CHANGE ORDER REQUEST

No. COR 157R

Project Name Tolleson Union High School No 7

Provide and install vault in Right of Way along Encanto Blvd as required by regulatory agencies (Cox) to provide communication utilities to the school's property.

ENG-18-0171

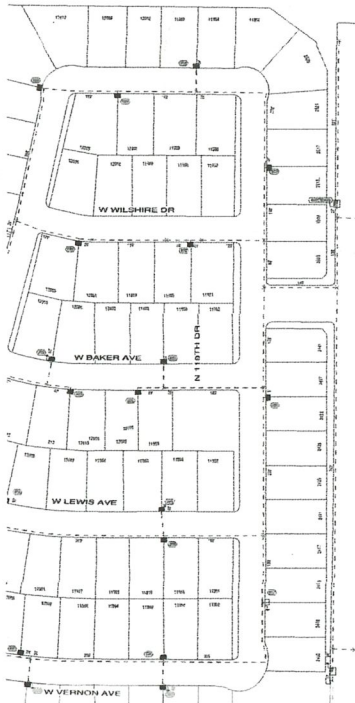
Please lay 3 3" conduit starting from the far west pole and stubbing up in the PUE next to where you are placing you "meet me vault" on property that we will tie into. Then stub down 3 more 2" conduits and continue run and stub up at the pole where we transition from Aerial to UG. We will intercept our existing conduit at that point and install a vault.

Intercept UG
conduit and
continue

This stretch
of run will be
converted to
UG from
aerial

2 splice cases not shown in myworld due to fiber repair on the spot . Remove these cases

Replace 24ct fiber
from AZFWL_S0933
to AZFWL_S1493 approx
2656'

Install lg fiber vault next to school vault with storage, and access to stub out to school.
